# DUKE POWER COMPANY MCGUIRE NUCLEAR STATION TECHNICAL SPECIFICATION 4.6.1.2d/10CFR50 APPENDIX J EXEMPTION REQUEST

Figure 1

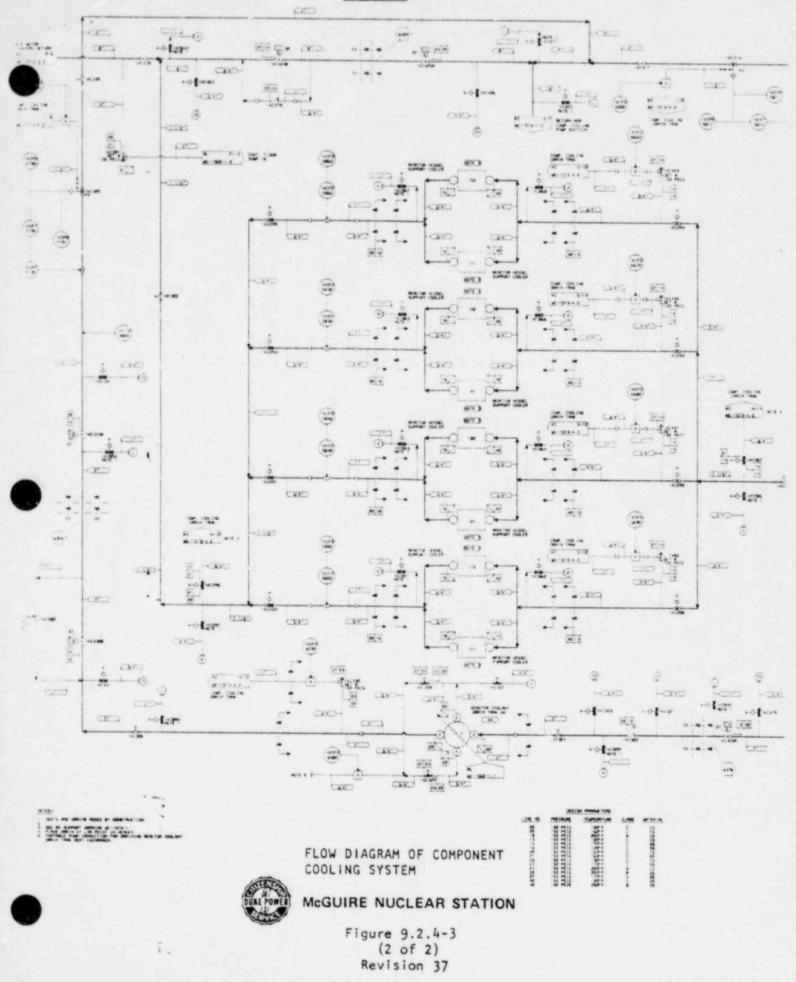
As shown on Figure 1 (excerpt from FSAR Figure 9.2.4-3 (2 of 2)), penetration M320 is on the component cooling (KC) line from components in the reactor building including the reactor coolant pump motor coolers. Testing of this penetration requires isolating and draining this portion of the line, and thus requires isolation of KC flow to the affected components. Therefore, Unit I would have to be shutdown and cooled down in order to switch to residual heat removal which would allow isolation of KC to reactor coolant pump motor coolers. Current estimate for shutdown, cooldown, penetration testing, and heatup is approximately 72 hours. More important is the thermal cycle which would be required only for the purpose of obtaining test results a few days earlier than otherwise available. In addition, the probability of the penetrations failure during the brief delay is extremely remote. Also, the NRC allows a grace period (generally + 25%) for many other types of testing and surveillance, including some valve leak testing pursuant to ASME Boiler and Pressure Vessel Code Section XI, Subsection IWV. The current outage planned to begin in mid-November allows more than sufficient time to complete this penetration test and all other required surveillance for 1982.

Component cooling system penetration M220 (component cooling water from reactor vessel support coolers and RCP coolers) was tested in May, 1979 and October, 1980. The results from these tests were 40 sccm and 45 sccm respectively. The total allowable leakage for penetrations is specified as 0.07 La or 6343 sccm at 14.8 psig. The average maximum allowable leakage for each of the 69 penetrations would be 92 sccm. Therefore, pene ration M320 has exhibited leakage rates less than half the maximum allowable for individual penetrations. The latest results for leakage rates of all penetrations shows a current total of 2187 sccm which is well below the allowable limit of 6343 sccm.

The past history shows the leak rate of the penetration has been well within the allowable limit and ther is no justification to assume the penetration will degrade beyond the allowable limit by November 30, 1982. Therefore, Duke believes this limited extension in the surveillance period does not involve an unreviewed safety question and has no effect on the health and safety of the public.
